**Re: Proposed Stationery Source Permit to Operate Dated October 19, 2007;
Mirant Potomac River Generating Station, Alexandria, Virginia.**

RE: Proposed Stationary Source Permit to Operate for the Mirant Potomac River Generating Station, Alexandria, Virginia, Dated October 19, 2007

**Re: Proposed Stationary Source Permit to Operate Dated October 19, 2007
Mirant Potomac River Generating Station, Alexandria, Virginia**

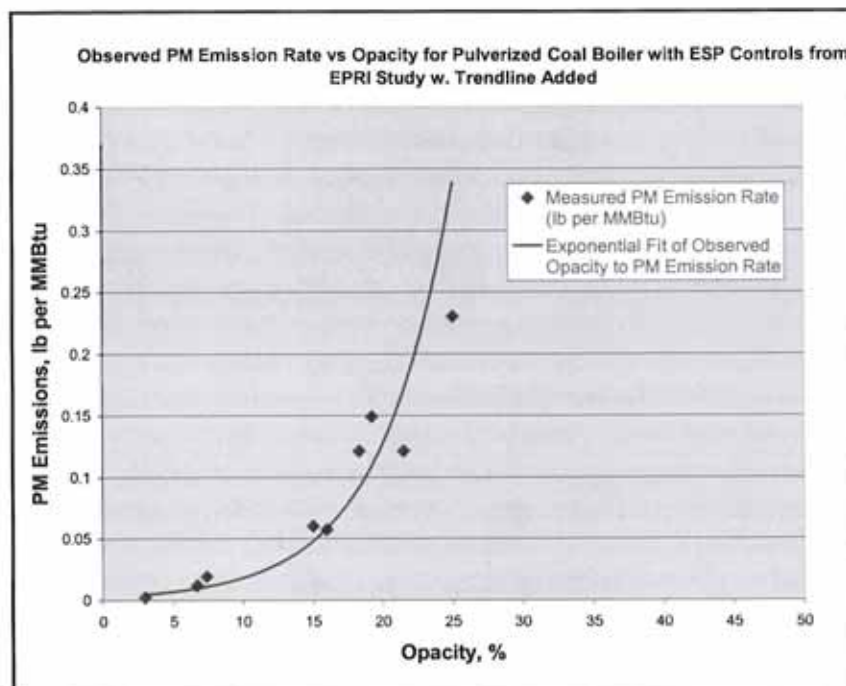
The figure below shows a curve fit between observed emission rates and opacity for testing of a pulverized coal boiler, obtained by Electric Power Research Interest Group, and reported by U.S. EPA.⁷ These data clearly show that opacity positively correlates with PM emissions. Of particular concern to Alexandria is the fact that opacity is closely related to fine particulate matter in the size range of about 1 μm . Therefore, any increase in opacity is very likely related to increases in PM_{2.5} emissions.

In response to Alexandria's recent request for data and analyses relating opacity increases to either increases or decreases in PM emissions, VDEQ wrote that it has "*determined that the information that you have requested cannot be found or does not exist in the records of the Department of Environmental Quality*" and that the VDEQ is "*not aware of another source of the information you requested.*" VDEQ also wrote that the "*Department is neither aware of nor in possession of the any documents, studies, or analyses relating the two or discussing the effect of increased opacity on emissions of total PM.*" Yet, VDEQ appears to agree with Mirant's claim that the December 2006 stack test demonstrated a reduction in PM emissions due to the use of trona. On the contrary, the December 2006 stack test is inadequate to make such a claim. First, the comparison of PM emissions with and without trona was only performed for one boiler that showed the smallest increase in opacity, i.e., Boiler 3. No other boiler was tested for this purpose. Second, the stack test reflects a one-time demonstration under controlled circumstances that are not representative of routine emissions. This is evidenced by the fact that Mirant has requested a PM emission limit of 0.055 lb/MMBtu, i.e., a limit that is two to five times higher than the actual stack test results. Additionally, and perhaps most importantly, the stack test results without trona use are based on a dismal performance of the cold-side ESP (CSEP3), i.e., an average PM control efficiency of only 53%. Such low control efficiency represents faulty performance of CSEP3 and resulted in higher PM emissions during the tests when trona was not in use. In contrast, the CSEP3 control efficiencies during the tests with trona ranged from 89% to 94%, which are more representative of the actual capability of CSEP3. Therefore, while the stack test with trona may reflect accurate emissions from Boiler 3, a comparison of these emissions with the results without trona is flawed and cannot be used to claim PM reduction due to trona use. Alexandria requests the Board and VDEQ to remove the reference to dry sorbent injection as a means to control PM emissions in Condition 5 of the proposed SOP.

Mirant opacity data showed increase in opacity with trona injection, and potentially PM_{2.5} emissions (~20,000 data points for each boiler)

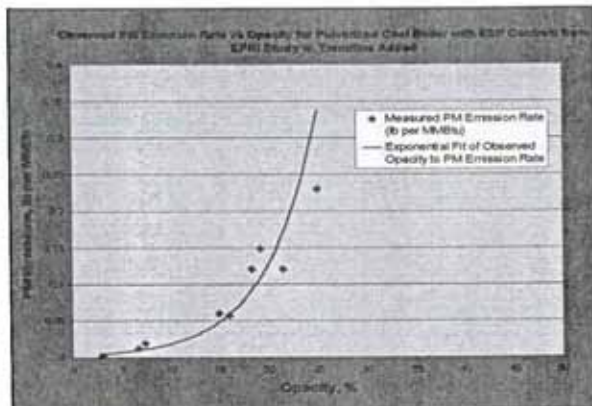
Boiler #3 showed the least negative impacts of trona on opacity. However, it was the only boiler used for comparing scenarios with and without trona in 2006 stack testing
